GUNITE DIVISION  
KELSEY - HAYES COMPANY

License No. 12-02360-02

In response to your letter dated 7/3/85, the following corrective action was taken on 7/16/85.

EXTENSION OF NORTH FENCE

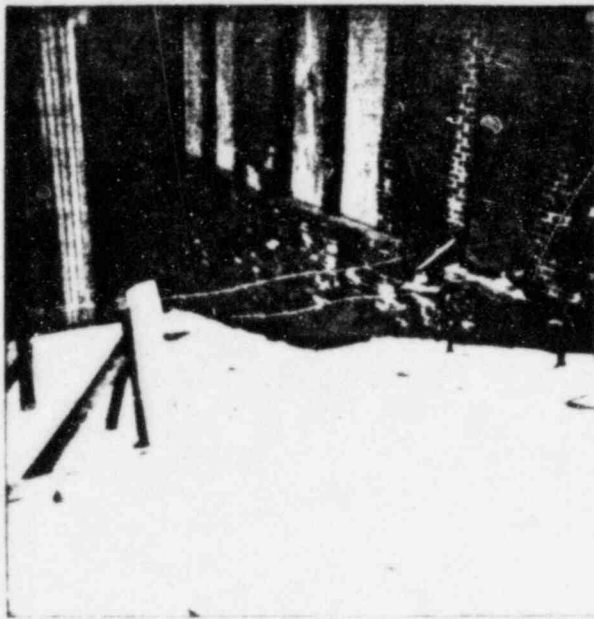
Barbed wire fencing has been extended from the existing fence, west to the outside brick wall, on both the north and south sides. See attached photographs. Also, two "Caution-High Radiation Area" signs were posted on the brick wall at the north and south ends on 7/18/85.
